DEVIATION REQUEST AND DECISION FORM

Project Name : Trails at Aspen Ridge Filing No. 2
Schedule No.(s) : 5500000412
Legal Description : Unplatted Land

A deviation from the standards of or in **Section 2.3.4** of the Engineering Criteria Manual (ECM) is requested.

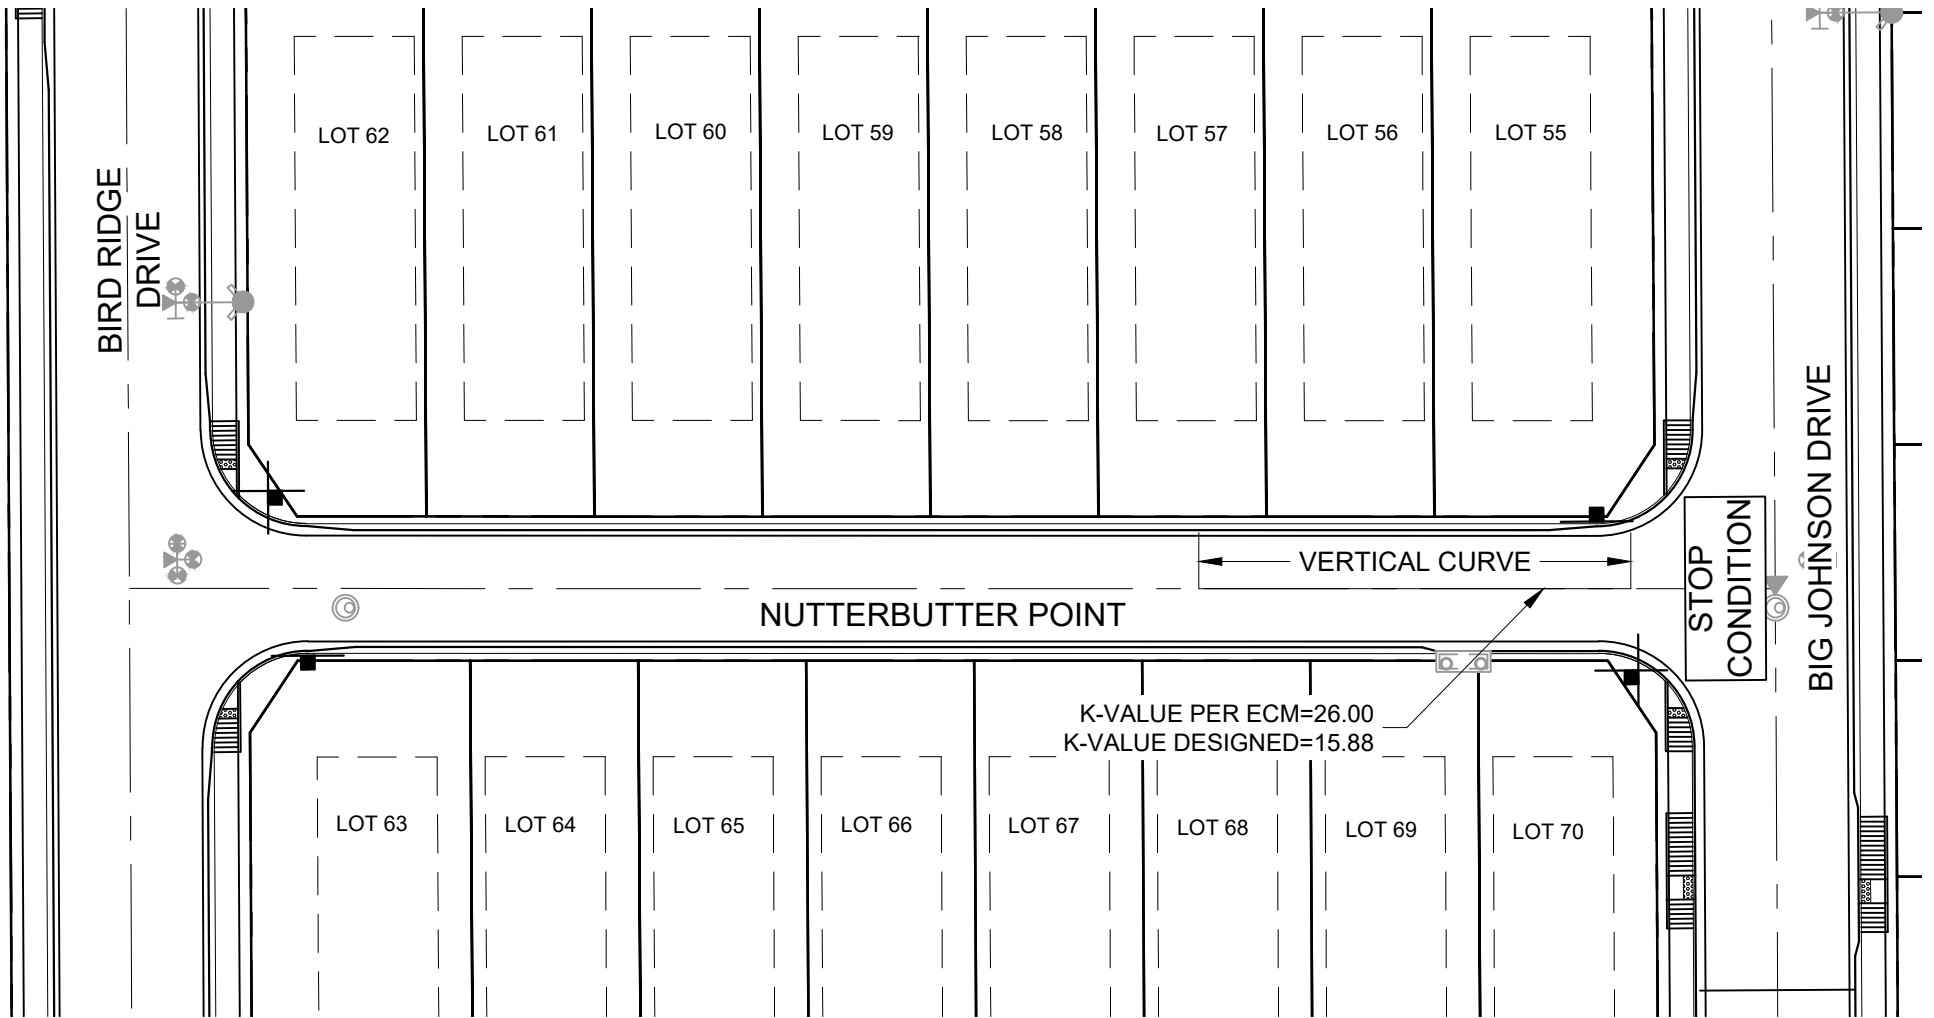
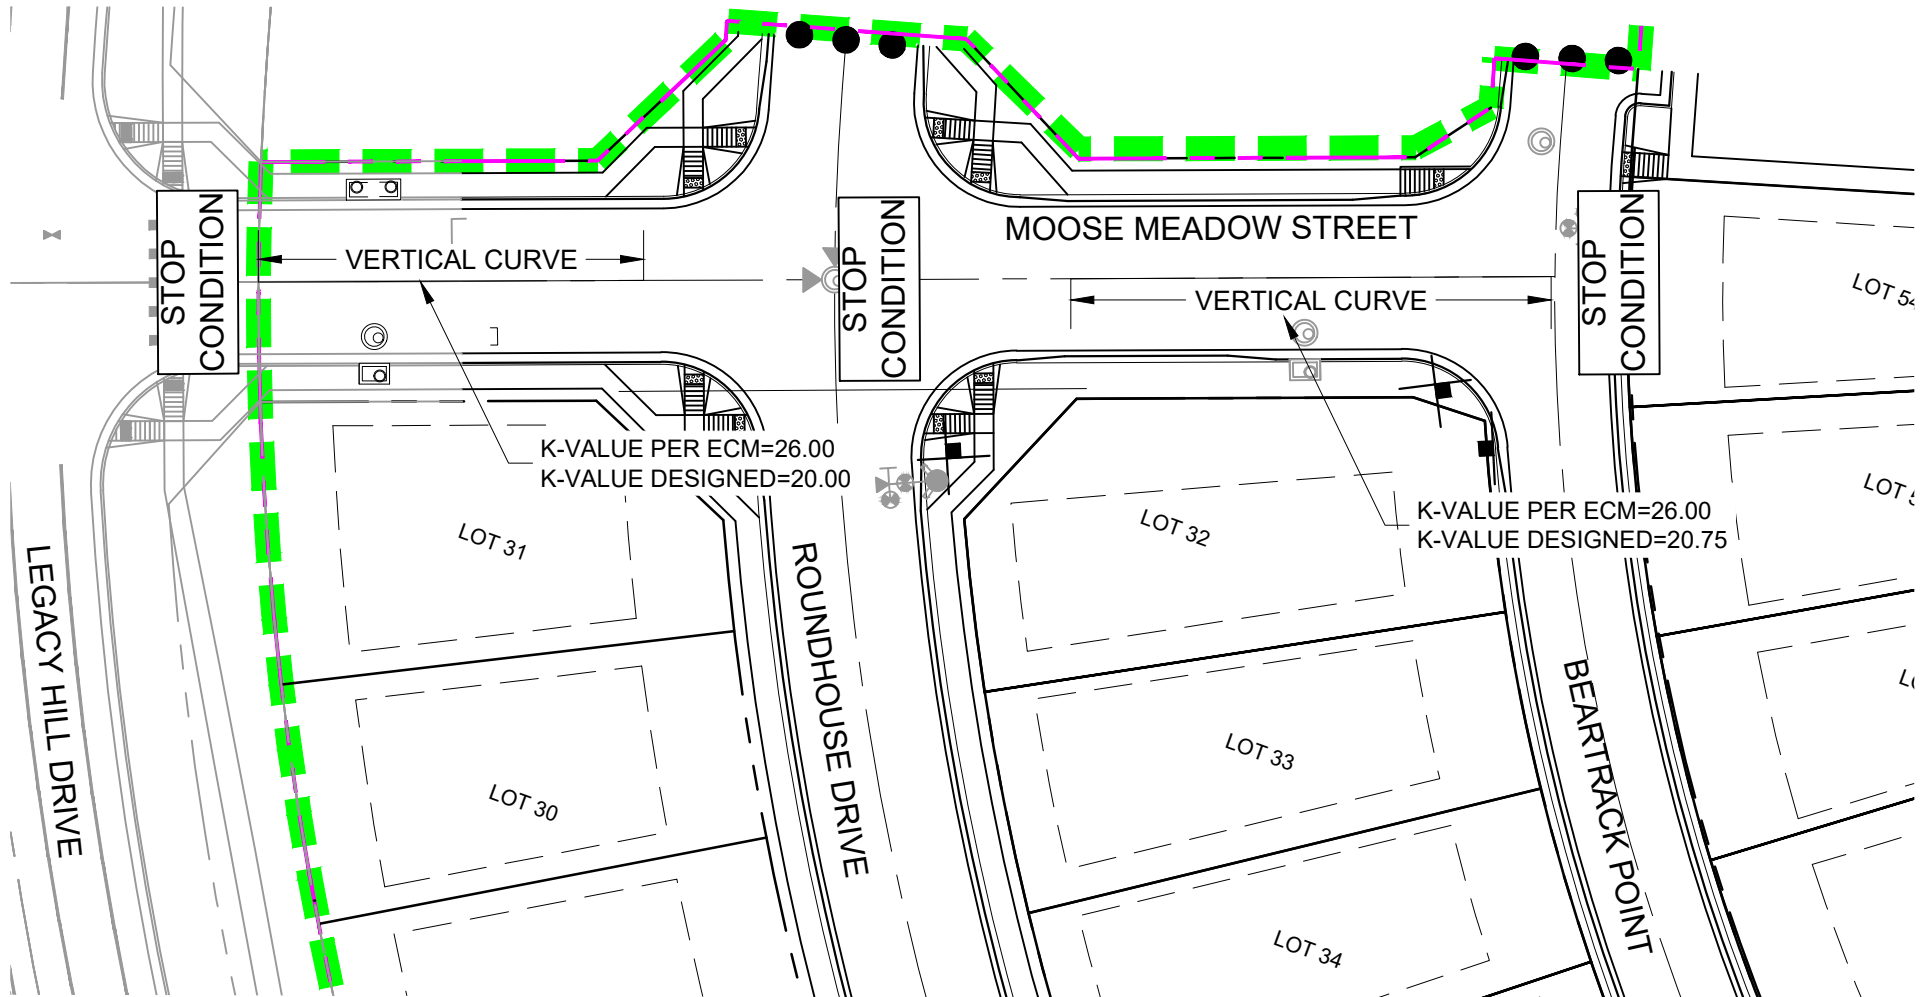
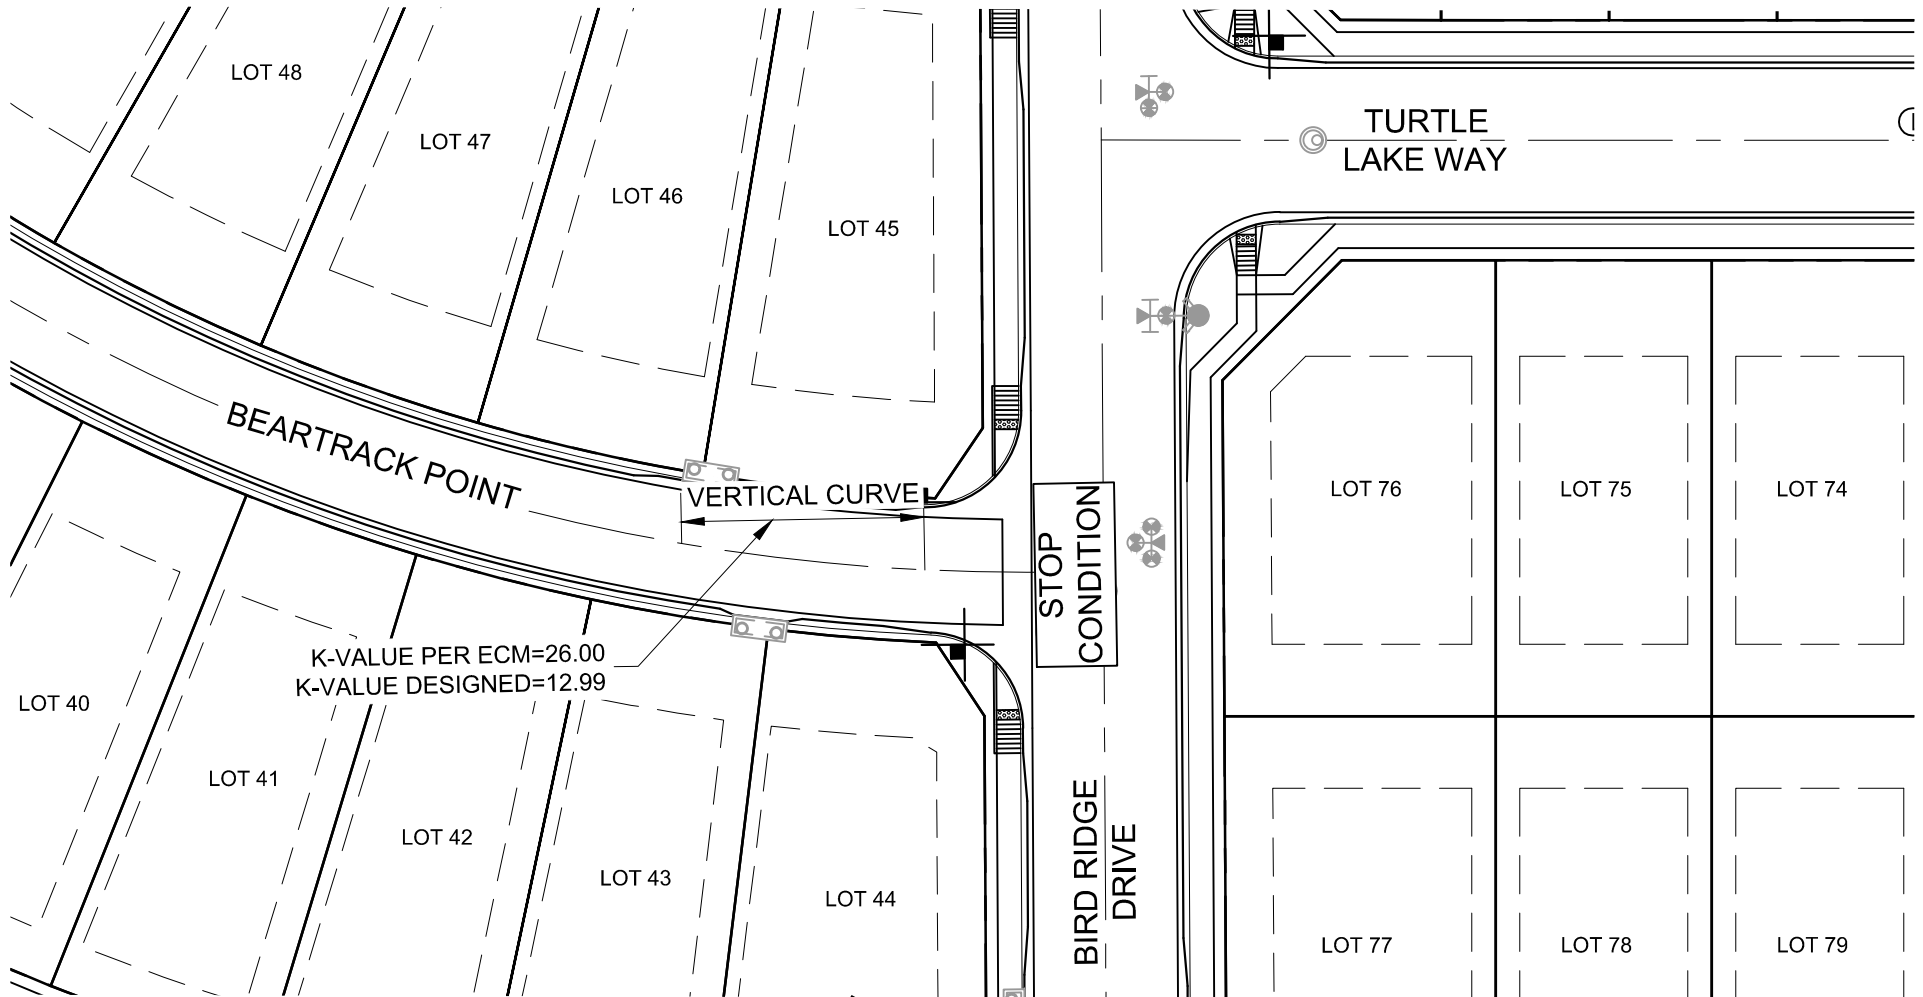
Approval of this deviation does not constitute approval of the configuration of the pedestrian ramps as shown on the exhibit.
